PCN #: 2439

PCN Title: Qualification of "Diodes Technology (Cheng Du) Company Limited" (CAT) as an Additional Assembly & Test Site, Using Gold Bond Wire, and as an Additional Wafer Back Grinding and Back Metal Process Source on Select MOSFET Products

PRODUCT CHANGE NOTICE

PCN-2439 REV 1

PowerDI5060-8L

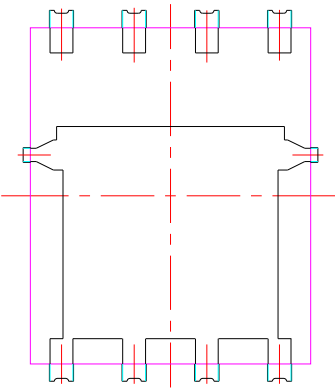
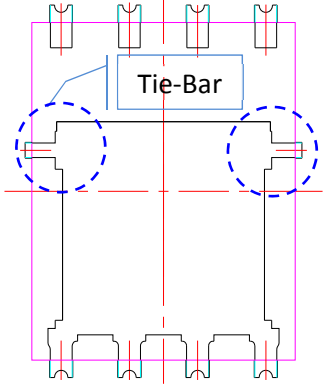
SAT (Current Diodes Internal AT site Shanghai, China)	CAT (Diodes Internal AT Site Chengdu, China) <u>Add bar "-" above Year D/C for CAT site</u>
Marking format example	Marking format example
 <p>DII = Manufacturer's Marking ABCDEFG = Product Type Marking Code YYWW = Date Code Marking YY = Year (ex: 13 = 2013) WW = Week (01 - 53)</p>	 <p>DII = Manufacturer's Marking ABCDEFG = Product Type Marking Code $\overline{YY}WW$ = Date Code Marking \overline{YY} = Year (ex: 13 = 2013) WW = Week (01 - 53)</p> <p>Other marking layout also will follow change for site Identifier</p>

SC-59

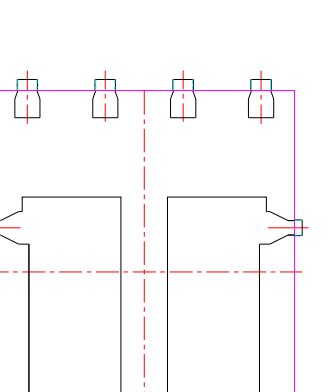
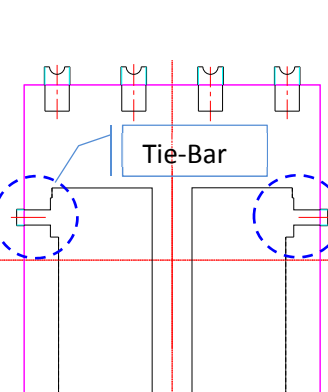
SAT (Current Diodes Internal AT site Shanghai, China)	CAT (Diodes Internal AT Site Chengdu, China) <u>Add bar "-" above Year D/C for CAT site</u>
Marking format example	Marking format example
 <p>N7=Product Type Marking Code YM=Date Code Marking Y= Year (ex: A=2013) M=Month (ex: 9=September)</p>	 <p>N7=Product Type Marking Code YM&\overline{Y}M=Date Code Marking \overline{Y}= Year (ex: A=2013) M=Month (ex: 9=September)</p> <p>Other marking layout also will follow change for site Identifier</p>

Table 5 - POD Format for PowerDI5060-8L (SC-59 remains the same)

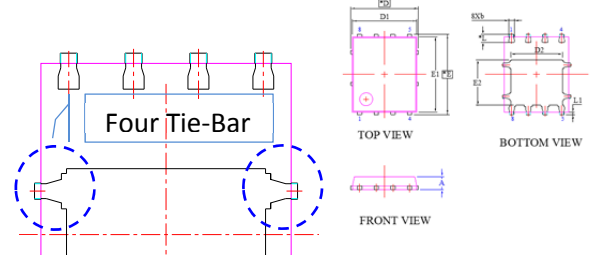
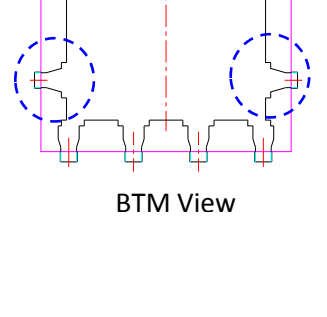
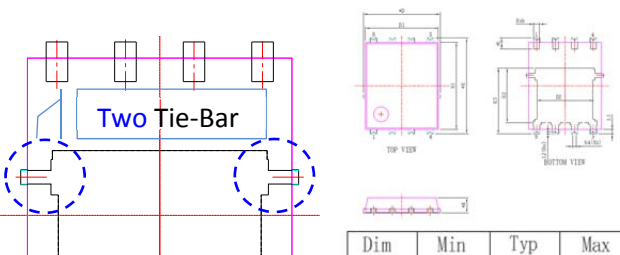
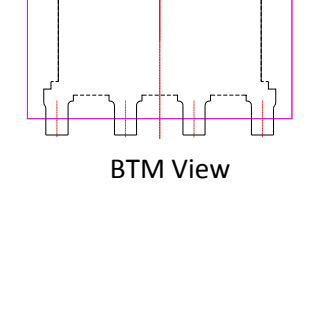
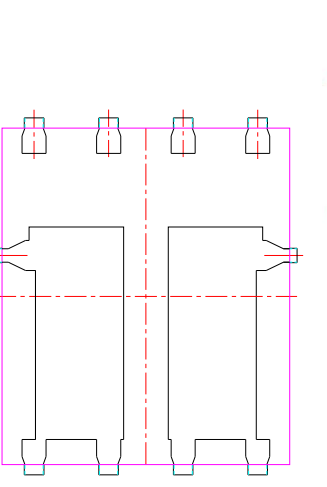
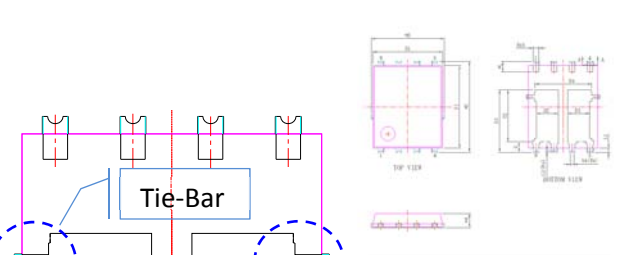
SAT		CAT																																																																																																																							
SWP-PoweDI5060-8L Q Type (With wettable flank)		SWP-PoweDI5060-8L Q Type (With wettable flank)																																																																																																																							
Base line: SAT existing POD design		Different tie-bar shape																																																																																																																							
 <p>BTM View</p> <table border="1"> <thead> <tr> <th>Dim</th> <th>Min</th> <th>Typ</th> <th>Max</th> </tr> </thead> <tbody> <tr> <td>*A</td> <td>0.975</td> <td>1.00</td> <td>1.025</td> </tr> <tr> <td>b</td> <td>0.36</td> <td>0.41</td> <td>0.46</td> </tr> <tr> <td>b4</td> <td colspan="3">0.25 REF</td> </tr> <tr> <td>*D</td> <td>5.05</td> <td>5.15</td> <td>5.25</td> </tr> <tr> <td>D1</td> <td>4.85</td> <td>4.90</td> <td>4.95</td> </tr> <tr> <td>D2</td> <td>3.66</td> <td>3.76</td> <td>3.86</td> </tr> <tr> <td>*E</td> <td>6.30</td> <td>6.40</td> <td>6.50</td> </tr> <tr> <td>E1</td> <td>5.75</td> <td>5.80</td> <td>5.85</td> </tr> <tr> <td>E2</td> <td>3.56</td> <td>3.66</td> <td>3.76</td> </tr> <tr> <td>*L</td> <td>0.635</td> <td>0.735</td> <td>0.835</td> </tr> <tr> <td>L1</td> <td>0.275</td> <td>0.300</td> <td>0.325</td> </tr> <tr> <td>L2</td> <td colspan="3">0.05 REF</td> </tr> </tbody> </table>	Dim	Min	Typ	Max	*A	0.975	1.00	1.025	b	0.36	0.41	0.46	b4	0.25 REF			*D	5.05	5.15	5.25	D1	4.85	4.90	4.95	D2	3.66	3.76	3.86	*E	6.30	6.40	6.50	E1	5.75	5.80	5.85	E2	3.56	3.66	3.76	*L	0.635	0.735	0.835	L1	0.275	0.300	0.325	L2	0.05 REF			 <p>Tie-Bar</p> <p>BTM View</p> <table border="1"> <thead> <tr> <th>Dim</th> <th>Min</th> <th>Typ</th> <th>Max</th> </tr> </thead> <tbody> <tr> <td>*A</td> <td>0.975</td> <td>1.00</td> <td>1.025</td> </tr> <tr> <td>b</td> <td>0.36</td> <td>0.41</td> <td>0.46</td> </tr> <tr> <td>b4</td> <td colspan="3">0.25 REF</td> </tr> <tr> <td>*D</td> <td>5.05</td> <td>5.15</td> <td>5.25</td> </tr> <tr> <td>D1</td> <td>4.85</td> <td>4.90</td> <td>4.95</td> </tr> <tr> <td>D2</td> <td>3.66</td> <td>3.76</td> <td>3.86</td> </tr> <tr> <td>*E</td> <td>6.30</td> <td>6.40</td> <td>6.50</td> </tr> <tr> <td>E1</td> <td>5.75</td> <td>5.80</td> <td>5.85</td> </tr> <tr> <td>E2</td> <td>3.56</td> <td>3.66</td> <td>3.76</td> </tr> <tr> <td>*L</td> <td>0.635</td> <td>0.735</td> <td>0.835</td> </tr> <tr> <td>L1</td> <td>0.275</td> <td>0.300</td> <td>0.325</td> </tr> <tr> <td>L2</td> <td colspan="3">0.05 REF</td> </tr> </tbody> </table>	Dim	Min	Typ	Max	*A	0.975	1.00	1.025	b	0.36	0.41	0.46	b4	0.25 REF			*D	5.05	5.15	5.25	D1	4.85	4.90	4.95	D2	3.66	3.76	3.86	*E	6.30	6.40	6.50	E1	5.75	5.80	5.85	E2	3.56	3.66	3.76	*L	0.635	0.735	0.835	L1	0.275	0.300	0.325	L2	0.05 REF

E1	5.75	5.80	5.85																																																																																																																						
E2	3.56	3.66	3.76																																																																																																																						
*L	0.635	0.735	0.835																																																																																																																						
L1	0.275	0.300	0.325																																																																																																																						
L2	0.05 REF																																																																																																																								
SWP-PoweDI5060-8L R Type (With wettable flank)		SWP-PoweDI5060-8L R Type (With wettable flank)																																																																																																																							
Base line: SAT existing POD design		Different tie-bar shape

<p align="center">PowerDI5060-8L Type (Without wettable flank)</p>	<p align="center">SWP-PoweDI5060-8L Q Type (With wettable flank)</p>																																																																																																																
<p align="center">Base line: SAT exist POD design</p>	<p align="center">- Four tie-bar to two tie-bar</p>																																																																																																																
<div style="display: flex; justify-content: space-around;"> <div style="text-align: center;">  <p>Four Tie-Bar</p> </div> <div style="text-align: center;">  </div> </div> <div style="text-align: center; margin-top: 20px;">  <p>BTM View</p> </div> <table border="1" style="margin-left: auto; margin-right: auto; border-collapse: collapse;"> <thead> <tr> <th>Dim</th> <th>Min</th> <th>Typ</th> <th>Max</th> </tr> </thead> <tbody> <tr> <td>*A</td> <td>0.975</td> <td>1.00</td> <td>1.025</td> </tr> <tr> <td>b</td> <td>0.36</td> <td>0.41</td> <td>0.46</td> </tr> <tr> <td>*D</td> <td>5.05</td> <td>5.15</td> <td>5.25</td> </tr> <tr> <td>D1</td> <td>4.85</td> <td>4.90</td> <td>4.95</td> </tr> <tr> <td>D2</td> <td></td> <td>3.98 TYP</td> <td></td> </tr> <tr> <td>*E</td> <td>6.05</td> <td>6.15</td> <td>6.25</td> </tr> <tr> <td>E1</td> <td>5.75</td> <td>5.80</td> <td>5.85</td> </tr> <tr> <td>E2</td> <td>3.56</td> <td>3.66</td> <td>3.725</td> </tr> <tr> <td>*L</td> <td>0.51</td> <td>0.61</td> <td>0.71</td> </tr> <tr> <td>L1</td> <td>0.10</td> <td>0.175</td> <td>0.20</td> </tr> </tbody> </table>	Dim	Min	Typ	Max	*A	0.975	1.00	1.025	b	0.36	0.41	0.46	*D	5.05	5.15	5.25	D1	4.85	4.90	4.95	D2		3.98 TYP		*E	6.05	6.15	6.25	E1	5.75	5.80	5.85	E2	3.56	3.66	3.725	*L	0.51	0.61	0.71	L1	0.10	0.175	0.20	<div style="display: flex; justify-content: space-around;"> <div style="text-align: center;">  <p>Two Tie-Bar</p> </div> <div style="text-align: center;">  </div> </div> <div style="text-align: center; margin-top: 20px;">  <p>BTM View</p> </div> <table border="1" style="margin-left: auto; margin-right: auto; border-collapse: collapse;"> <thead> <tr> <th>Dim</th> <th>Min</th> <th>Typ</th> <th>Max</th> </tr> </thead> <tbody> <tr> <td>*A</td> <td>0.975</td> <td>1.00</td> <td>1.025</td> </tr> <tr> <td>b</td> <td>0.36</td> <td>0.41</td> <td>0.46</td> </tr> <tr> <td>b4</td> <td></td> <td>0.25 REF</td> <td></td> </tr> <tr> <td>*D</td> <td>5.05</td> <td>5.15</td> <td>5.25</td> </tr> <tr> <td>D1</td> <td>4.85</td> <td>4.90</td> <td>4.95</td> </tr> <tr> <td>D2</td> <td>3.66</td> <td>3.76</td> <td>3.86</td> </tr> <tr> <td>*E</td> <td>6.30</td> <td>6.40</td> <td>6.50</td> </tr> <tr> <td>E1</td> <td>5.75</td> <td>5.80</td> <td>5.85</td> </tr> <tr> <td>E2</td> <td>3.56</td> <td>3.66</td> <td>3.76</td> </tr> <tr> <td>*L</td> <td>0.635</td> <td>0.735</td> <td>0.835</td> </tr> <tr> <td>L1</td> <td>0.275</td> <td>0.300</td> <td>0.325</td> </tr> <tr> <td>L2</td> <td></td> <td>0.05 REF</td> <td></td> </tr> </tbody> </table>	Dim	Min	Typ	Max	*A	0.975	1.00	1.025	b	0.36	0.41	0.46	b4		0.25 REF		*D	5.05	5.15	5.25	D1	4.85	4.90	4.95	D2	3.66	3.76	3.86	*E	6.30	6.40	6.50	E1	5.75	5.80	5.85	E2	3.56	3.66	3.76	*L	0.635	0.735	0.835	L1	0.275	0.300	0.325	L2		0.05 REF

<p align="center">PowerDI5060-8L E Type (Without wettable flank)</p>	<p align="center">SWP-PoweDI5060-8L R Type (With wettable flank)</p>																																																																																																																
<p align="center">Base line: SAT exist POD design</p>	<p align="center">Different tie-bar shape</p>																																																																																																																
<div style="display: flex; justify-content: space-around;"> <div style="text-align: center;">  <p>BTM View</p> </div> <div style="text-align: center;">  </div> </div> <table border="1" style="margin-left: auto; margin-right: auto; border-collapse: collapse;"> <thead> <tr> <th>Dim</th> <th>Min</th> <th>Typ</th> <th>Max</th> </tr> </thead> <tbody> <tr> <td>*A</td> <td>0.975</td> <td>1.00</td> <td>1.025</td> </tr> <tr> <td>b</td> <td>0.36</td> <td>0.41</td> <td>0.46</td> </tr> <tr> <td>*D</td> <td>5.05</td> <td>5.15</td> <td>5.25</td> </tr> <tr> <td>D1</td> <td>4.85</td> <td>4.90</td> <td>4.95</td> </tr> <tr> <td>D2</td> <td>1.40</td> <td>1.50</td> <td>1.60</td> </tr> <tr> <td>D3</td> <td>1.40</td> <td>1.50</td> <td>1.60</td> </tr> <tr> <td>D4</td> <td></td> <td>3.98 TYP</td> <td></td> </tr> <tr> <td>*E</td> <td>6.05</td> <td>6.15</td> <td>6.25</td> </tr> <tr> <td>E1</td> <td>5.75</td> <td>5.80</td> <td>5.85</td> </tr> <tr> <td>E2</td> <td>3.56</td> <td>3.66</td> <td>3.76</td> </tr> <tr> <td>*L</td> <td>0.51</td> <td>0.61</td> <td>0.71</td> </tr> <tr> <td>L1</td> <td>0.10</td> <td>0.175</td> <td>0.20</td> </tr> </tbody> </table>	Dim	Min	Typ	Max	*A	0.975	1.00	1.025	b	0.36	0.41	0.46	*D	5.05	5.15	5.25	D1	4.85	4.90	4.95	D2	1.40	1.50	1.60	D3	1.40	1.50	1.60	D4		3.98 TYP		*E	6.05	6.15	6.25	E1	5.75	5.80	5.85	E2	3.56	3.66	3.76	*L	0.51	0.61	0.71	L1	0.10	0.175	0.20	<div style="display: flex; justify-content: space-around;"> <div style="text-align: center;">  <p>Tie-Bar</p> </div> <div style="text-align: center;">  </div> </div> <div style="text-align: center; margin-top: 20px;">  <p>BTM View</p> </div> <table border="1" style="margin-left: auto; margin-right: auto; border-collapse: collapse;"> <thead> <tr> <th>Dim</th> <th>Min</th> <th>Typ</th> <th>Max</th> </tr> </thead> <tbody> <tr> <td>*A</td> <td>0.975</td> <td>1.00</td> <td>1.025</td> </tr> <tr> <td>b</td> <td>0.36</td> <td>0.41</td> <td>0.46</td> </tr> <tr> <td>b4</td> <td></td> <td>0.25 REF</td> <td></td> </tr> <tr> <td>*D</td> <td>5.05</td> <td>5.15</td> <td>5.25</td> </tr> <tr> <td>D1</td> <td>4.80</td> <td>4.90</td> <td>5.00</td> </tr> <tr> <td>D2</td> <td>1.40</td> <td>1.50</td> <td>1.60</td> </tr> <tr> <td>D3</td> <td>1.40</td> <td>1.50</td> <td>1.60</td> </tr> <tr> <td>D4</td> <td>3.88</td> <td>3.98</td> <td>4.08</td> </tr> <tr> <td>*E</td> <td>6.30</td> <td>6.40</td> <td>6.50</td> </tr> <tr> <td>E1</td> <td>5.75</td> <td>5.80</td> <td>5.85</td> </tr> <tr> <td>E2</td> <td>3.56</td> <td>3.66</td> <td>3.76</td> </tr> <tr> <td>*L</td> <td>0.635</td> <td>0.735</td> <td>0.835</td> </tr> <tr> <td>L1</td> <td>0.275</td> <td>0.300</td> <td>0.325</td> </tr> <tr> <td>L2</td> <td></td> <td>0.05 REF</td> <td></td> </tr> </tbody> </table>	Dim	Min	Typ	Max	*A	0.975	1.00	1.025	b	0.36	0.41	0.46	b4		0.25 REF		*D	5.05	5.15	5.25	D1	4.80	4.90	5.00	D2	1.40	1.50	1.60	D3	1.40	1.50	1.60	D4	3.88	3.98	4.08	*E	6.30	6.40	6.50	E1	5.75	5.80	5.85	E2	3.56	3.66	3.76	*L	0.635	0.735	0.835	L1	0.275	0.300	0.325	L2		0.05 REF
